Staff Report

Site Plan Review

Basement Apartment Conversion

SP-12-20

Exhibit 'C-2'

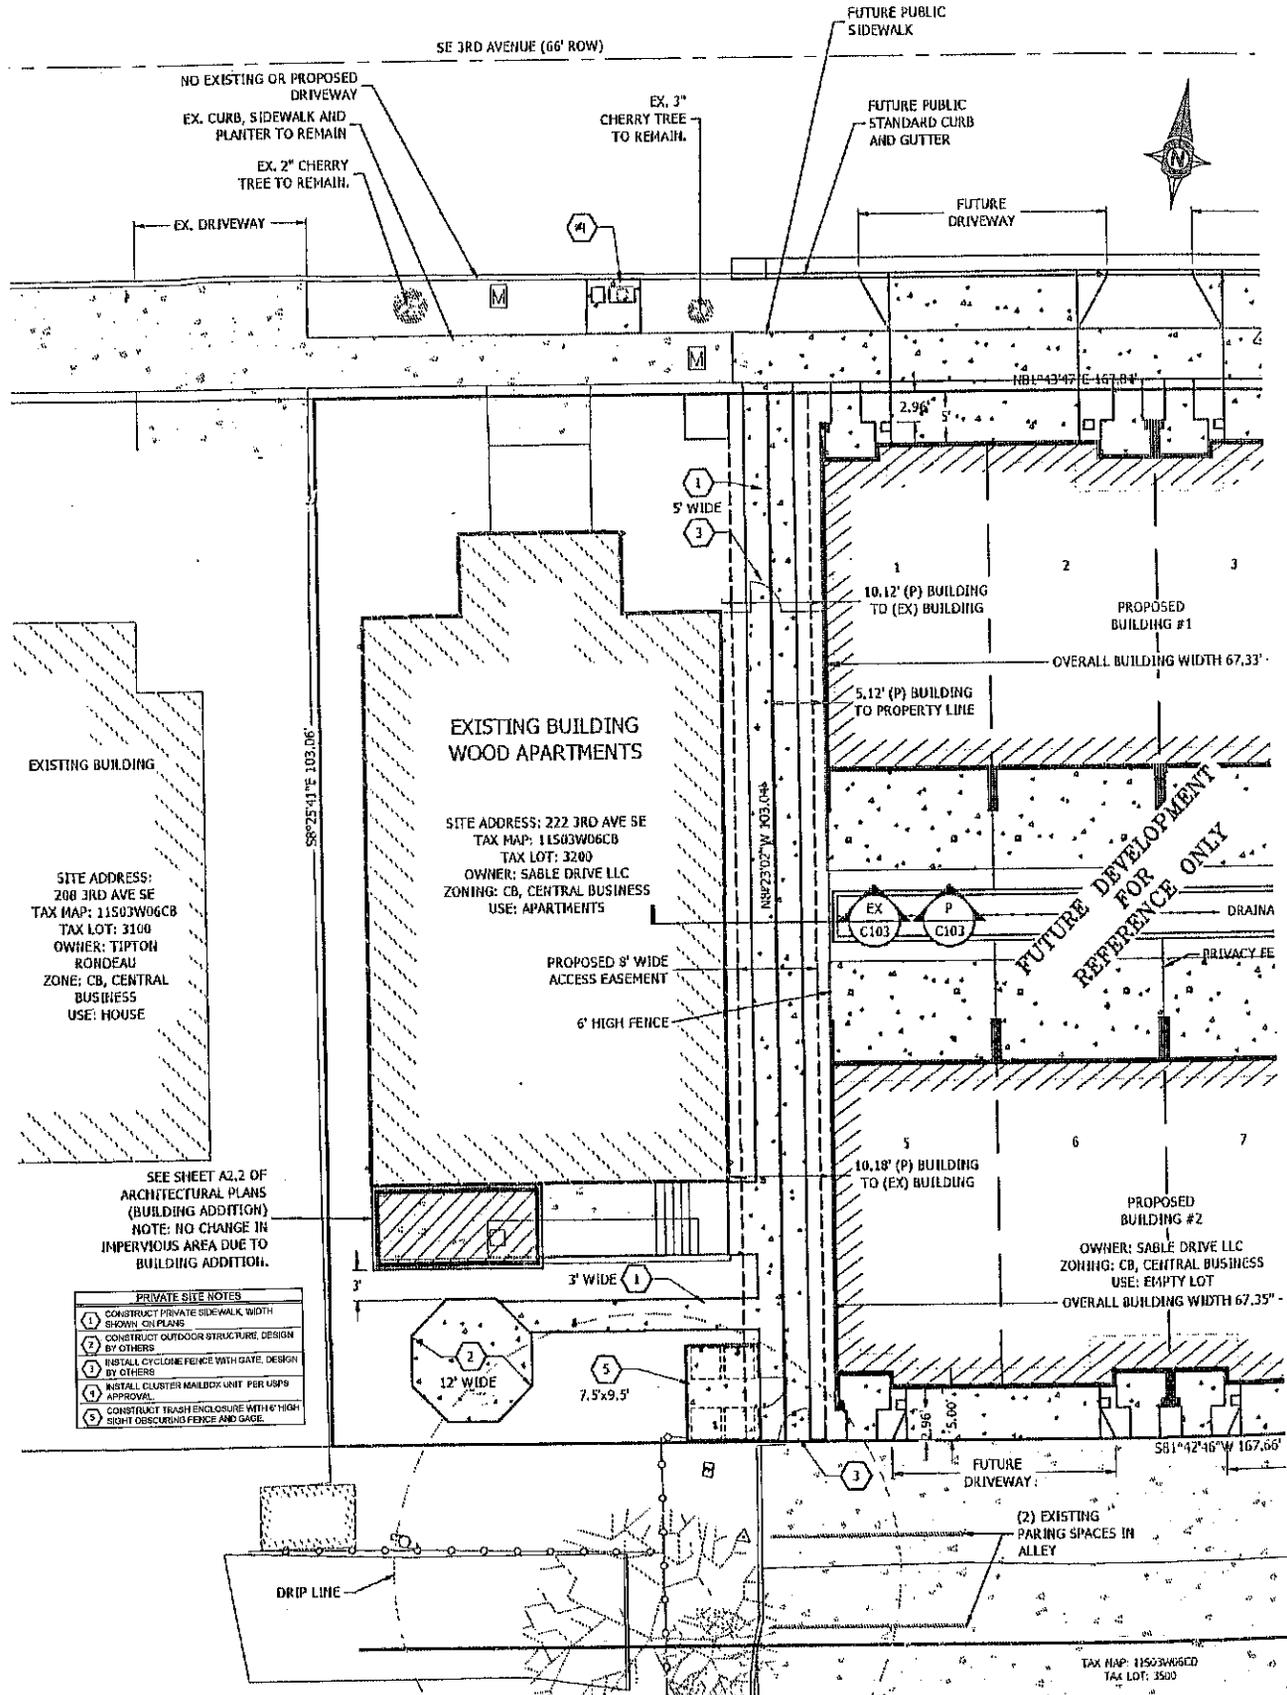
As shown on the site plan (Attachment B.6), the proposed refuse area is located to the southeast of the site adjacent to the alleyway. The refuse container is not within 15 feet of any dwelling window and is not located in a required setback area or buffer yard. As shown on the site plan (Attachment B.6), a sight-obscuring fence and gate approximately six feet tall is proposed. Therefore, this standard is met.

Exhibit 'T' Conceptual Landscape Plan

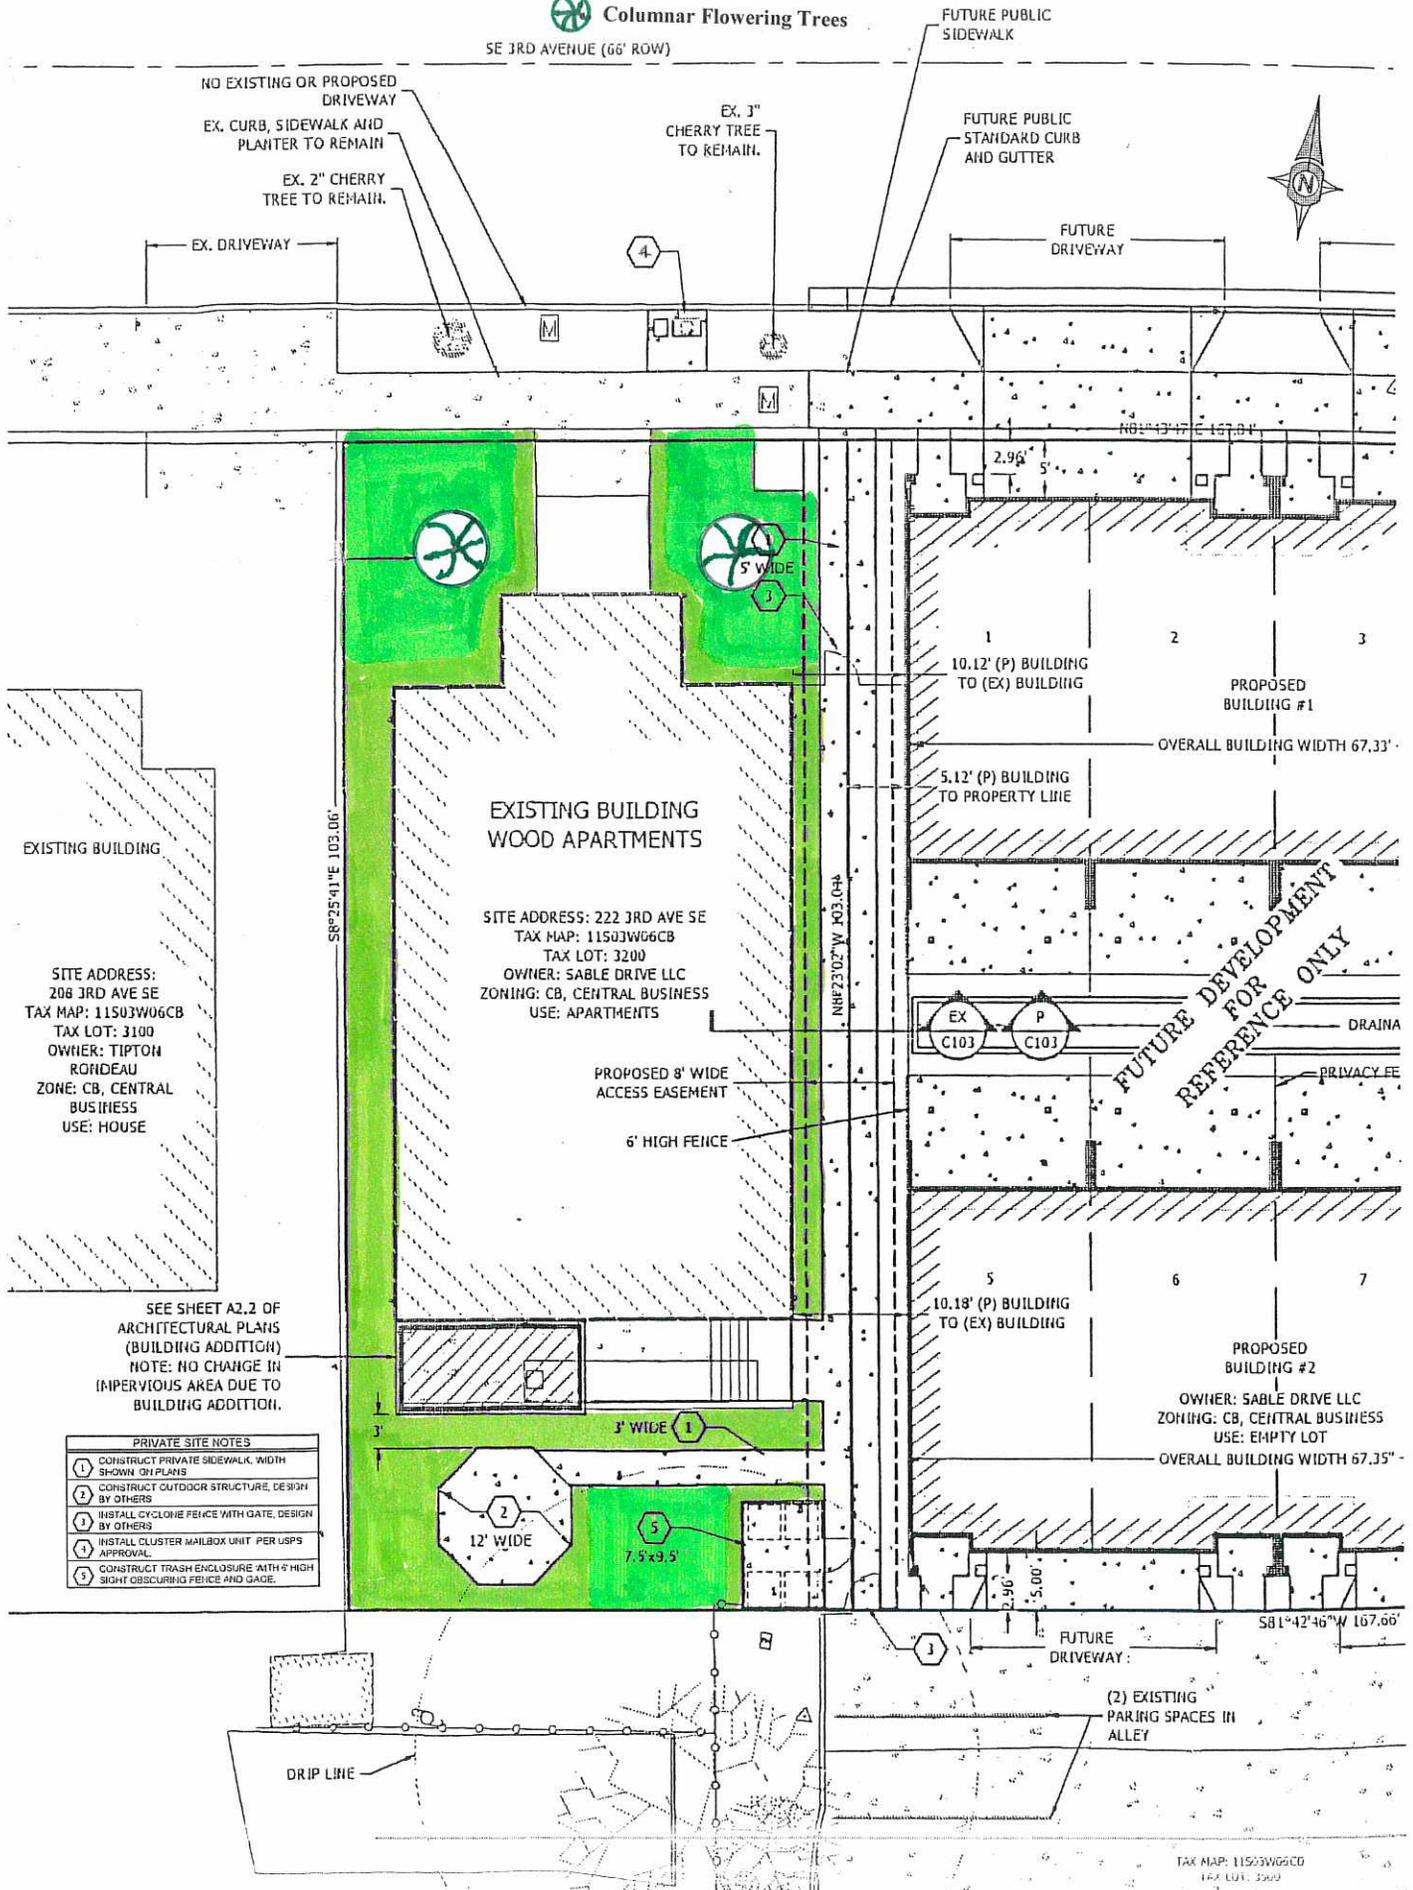
The Conceptual Landscape Plan indicated columnar flowering tree and grass will be planted in the front yard area but does not provide details to confirm the code standards are met.

A final landscape plan consistent with the standards of ADC 9.140(1) will need to be submitted for review and approval by the Community Development Department before building permits can be issued.
